EAGLE MOUNTAIN PLANNING COMMISSION MEETING

March 22, 2022, 5:30 PM

7.A ACTION ITEM - Marketplace at Eagle Mountain Town Center Lot 6 Pad C2

A site plan for a commercial pad building located on lot 6 of the Eagle Mountain Town Center development.

Site Plan

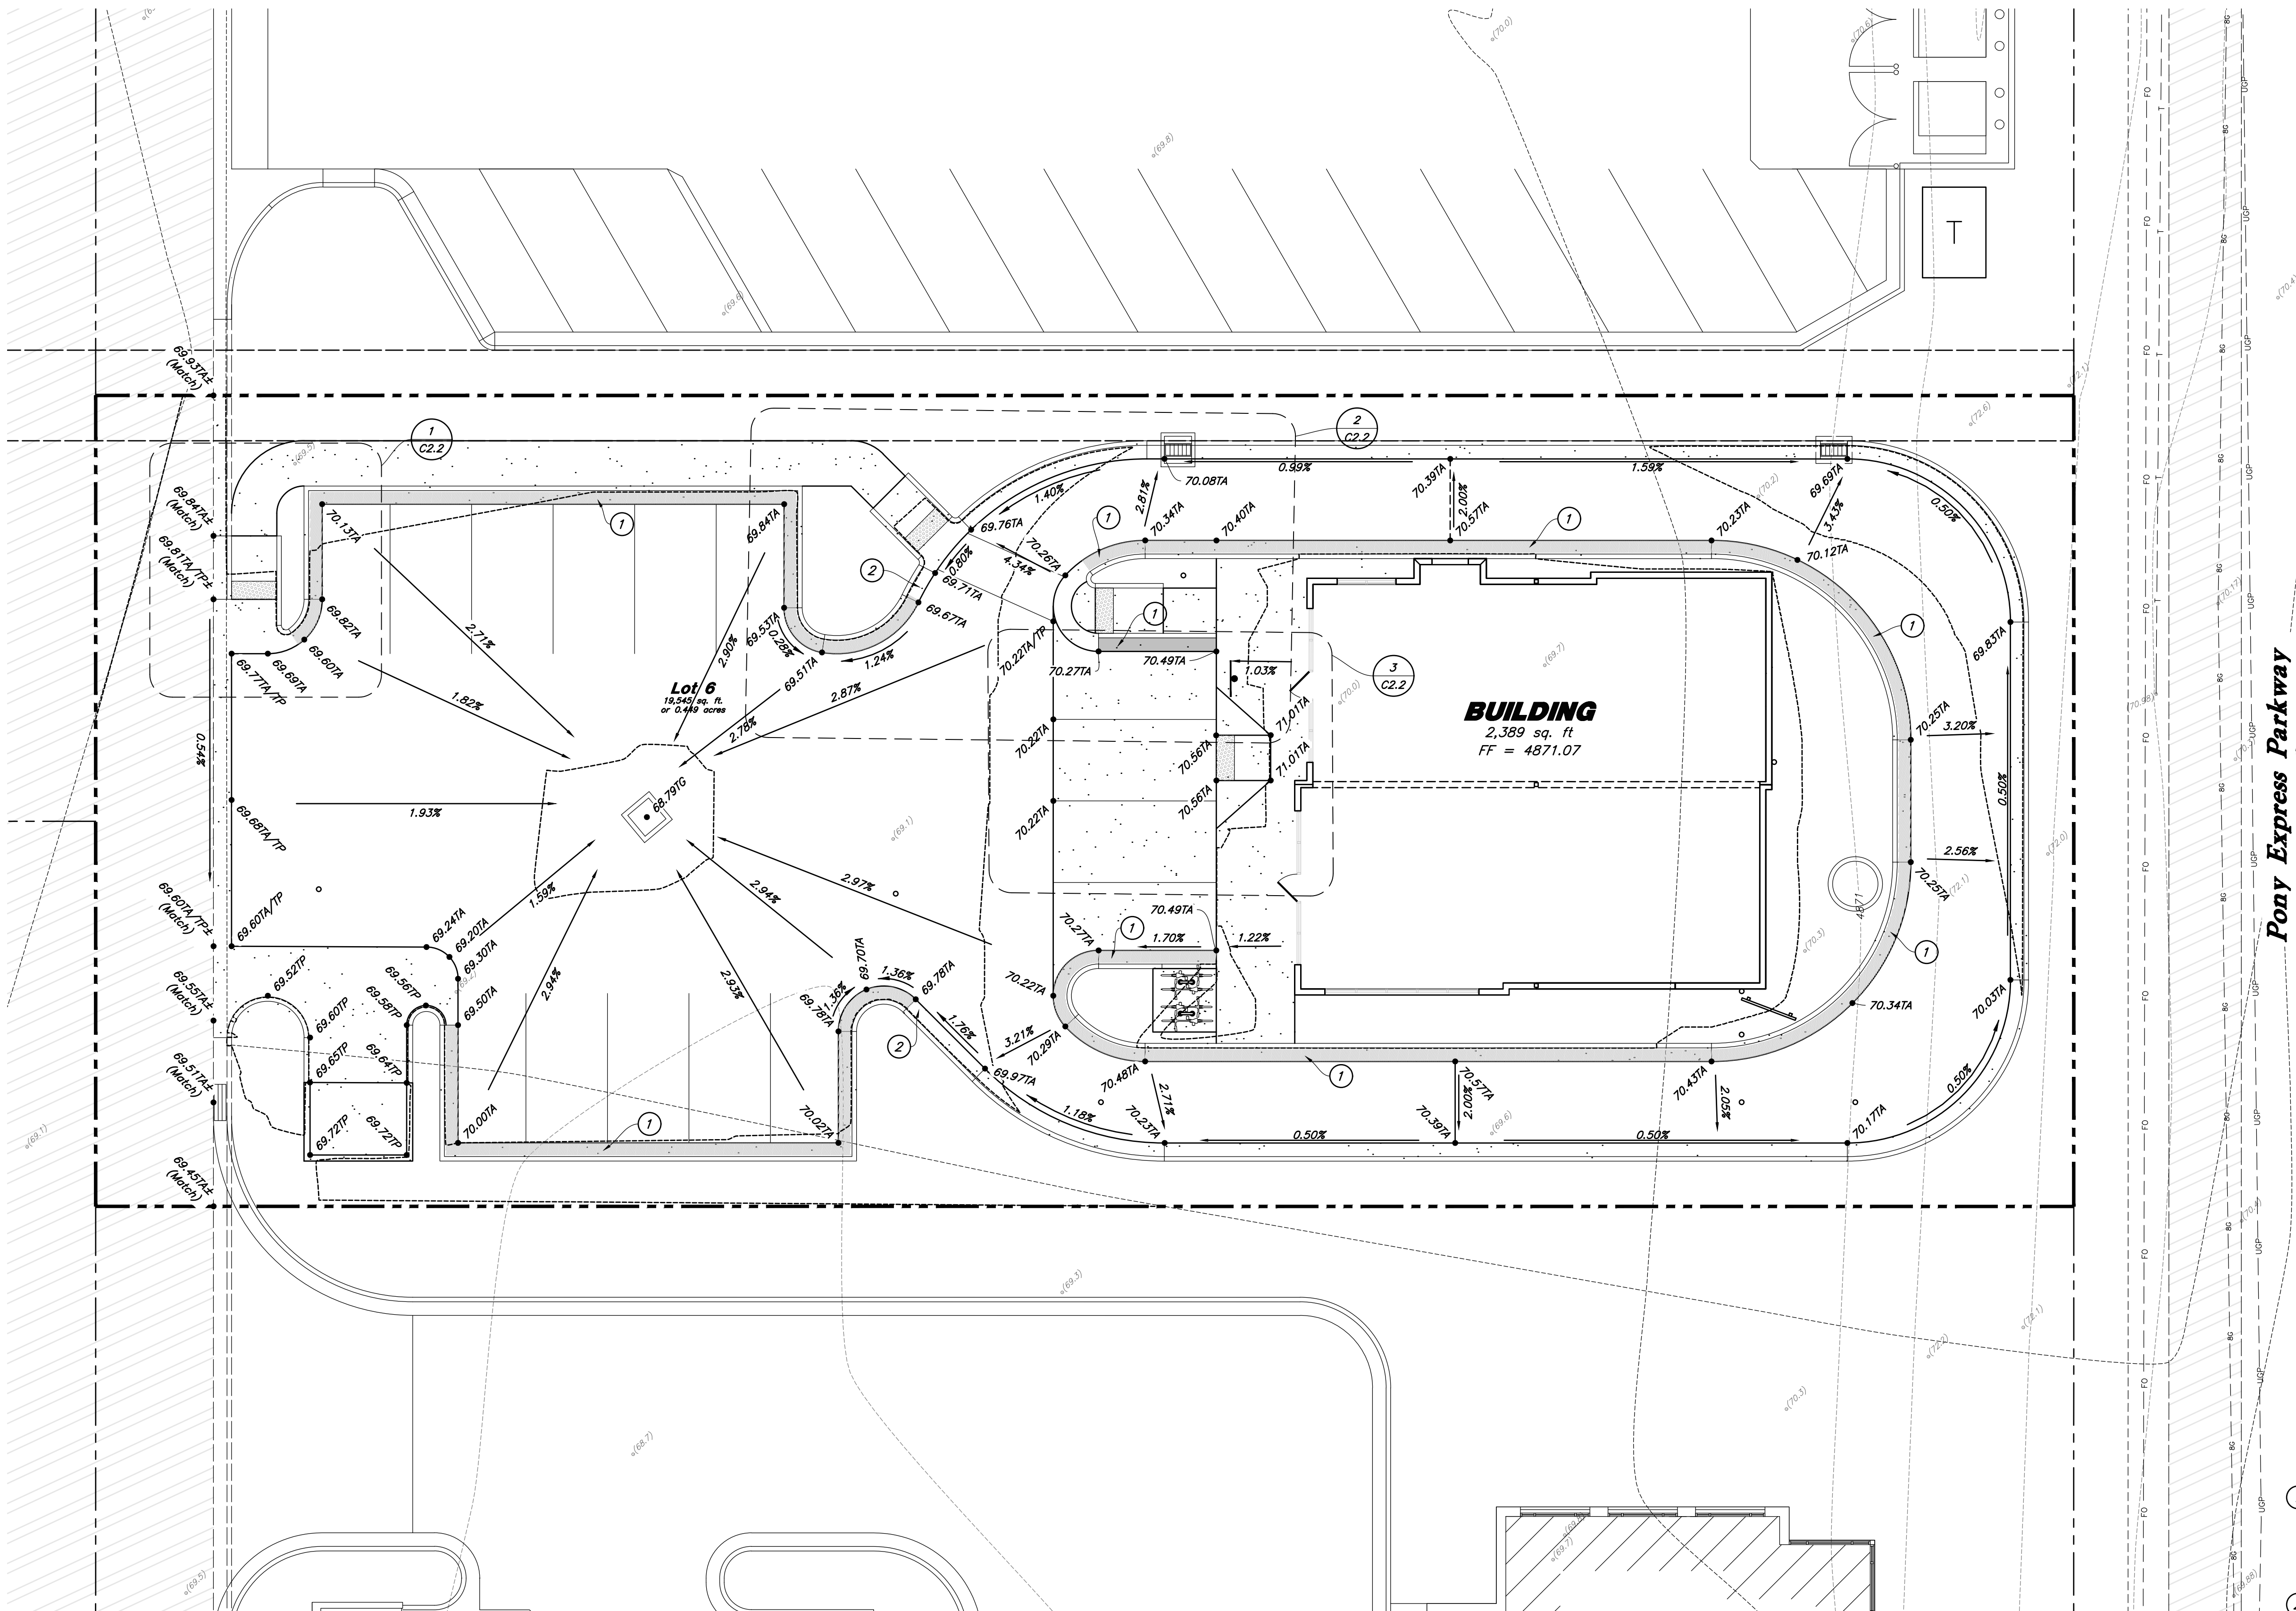
17.72.030 A requires buildings be located at or near the front setback with pedestrian access leading to the primary entrance and with landscaping between the building and the street. The building is located adjacent to Pony Express Parkway, but there is a drive-thru between the building and Pony Express Parkway, which prohibits pedestrian connections to the East elevation. A crosswalk is provided from the internal access located West of the front of the building, it crosses the drive-thru on the north side of the building. Ideally this building would also provide Pedestrian access to the improved trail that runs along Pony Express Parkway to the East. It shall be up to the Planning Commission to determine if this complies with code.

1. A pedestrian connection is provided to the improved walking path along Pony Express Parkway to the East of the project.
2. Awnings shall be added to the East Elevation

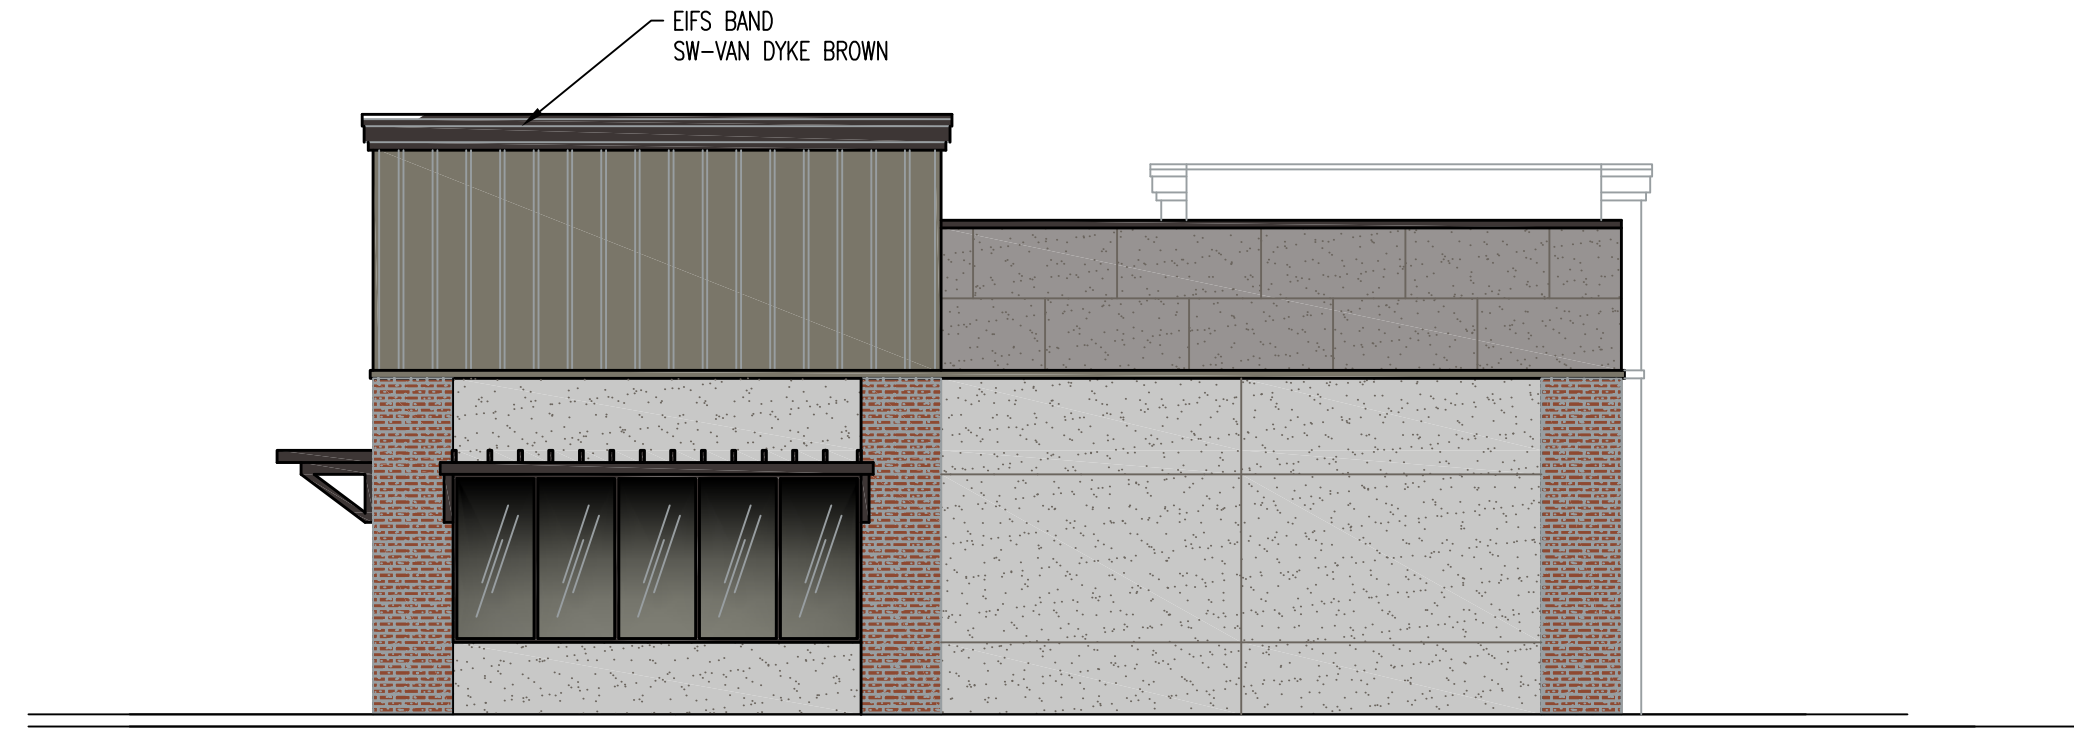
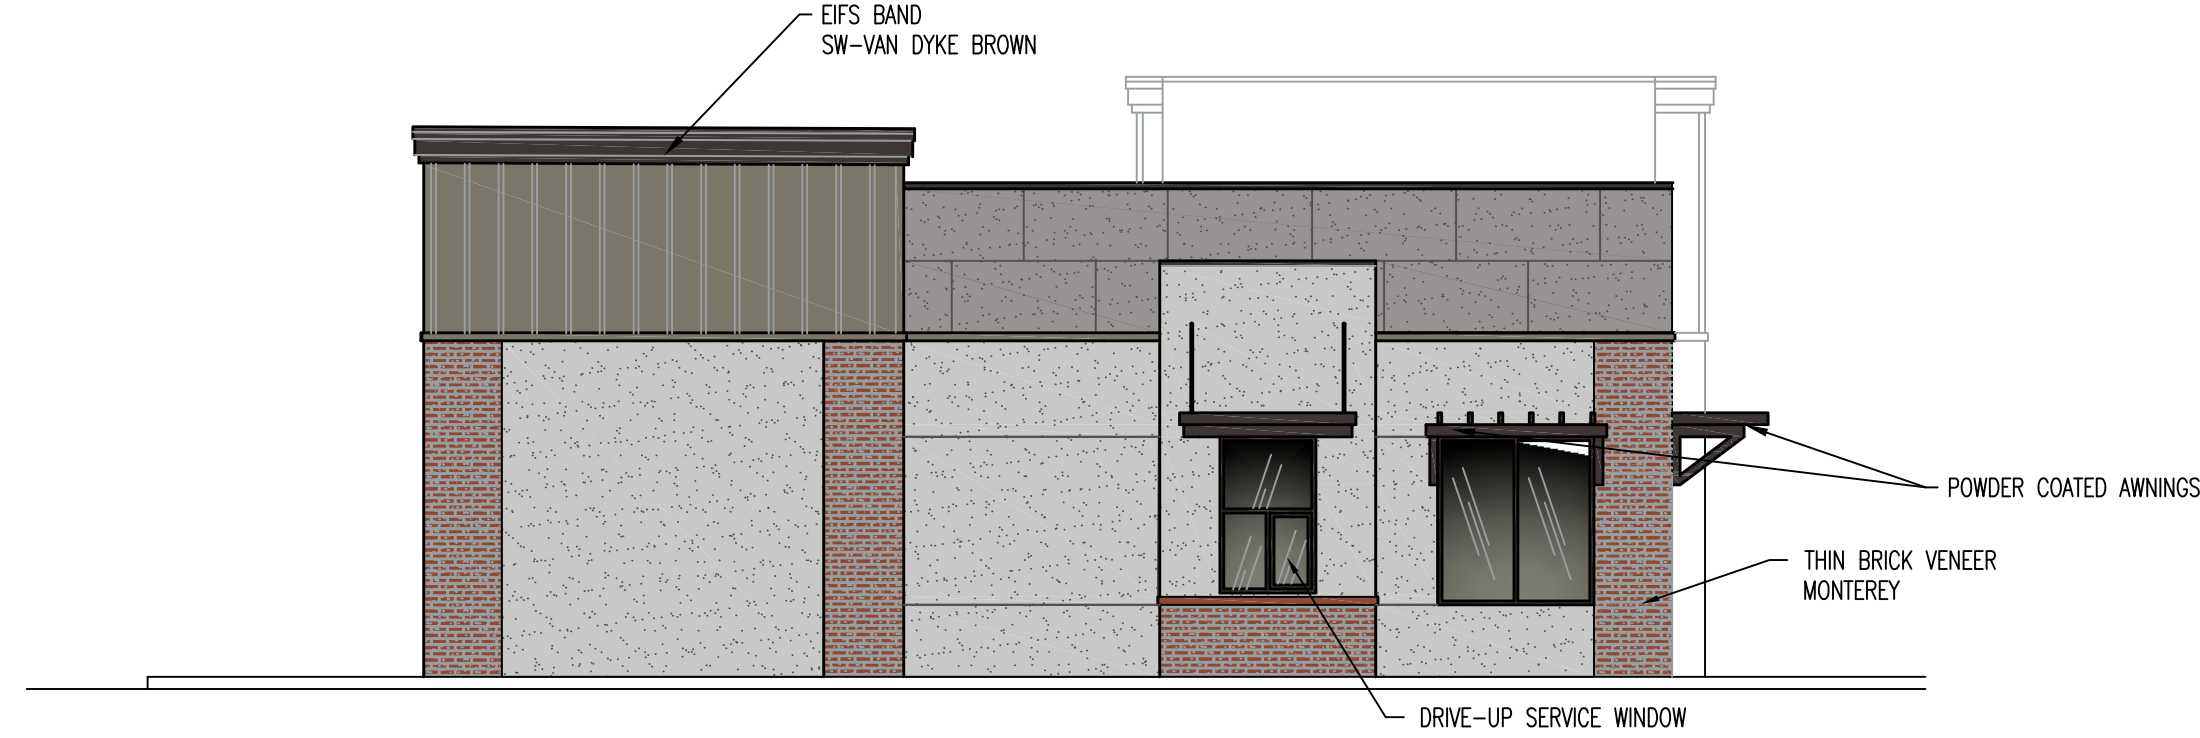
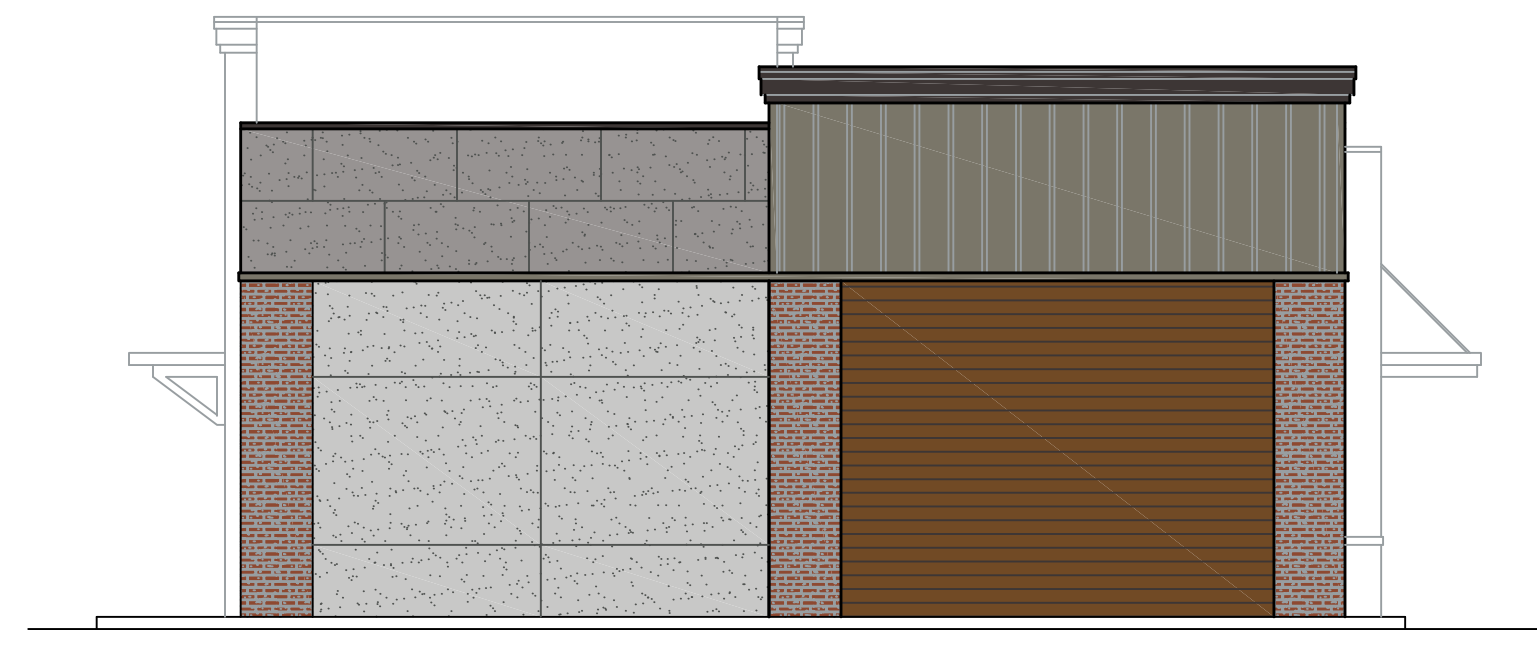
17.72.030 A1 requires the primary entrance of a commercial building to orient toward the street and the sidewalk. The main entrance to the building is located on the West Elevation which opens to the main parking area with the rear (East elevation) facing toward Pony Express Parkway. It is the opinion of staff that the proposal doesn't orient the building to the road or a pedestrian way. As there are no entrances on the East elevation and a pedestrian access is provided from the west the Planning Commission may determine if this is appropriate or not.

17.72.040 A requires that commercial buildings be similar in style to adjacent buildings, and that all facades of the building be designed with consistent architectural style, detail, and trim features as the primary façade. The proposed Pad site elevations are similar in look to the approved Marketplace at Eagle Mountain Town Center pad site elevations, and have been updated to include color schemes closer to those used in already approved pad buildings, it is the opinion of staff that elevations largely comply with code.

17.72.040 B states "the main entrance of a structure should orient to major sidewalks, pedestrian ways, plazas, courtyards, or other public spaces. It shall be clearly identifiable, and consist of a sheltering element such a porch, stoop, awning, arcade, or portico. The main entrance of the structure orients towards the parking area, with the rear (East elevation) being the most plain of the elevations. Staff recommends additional details and features, such as awnings, be added to the East elevation.

17.72.040 F2 states: "All commercial buildings shall avoid large panelized products or featureless surfaces. Commercial buildings shall utilize an appropriate mixture of building materials on all sides..." It shall be up to the Planning Commission to determine if the The North, South, and East elevation include large featureless surface or if you feel they comply with this standard.
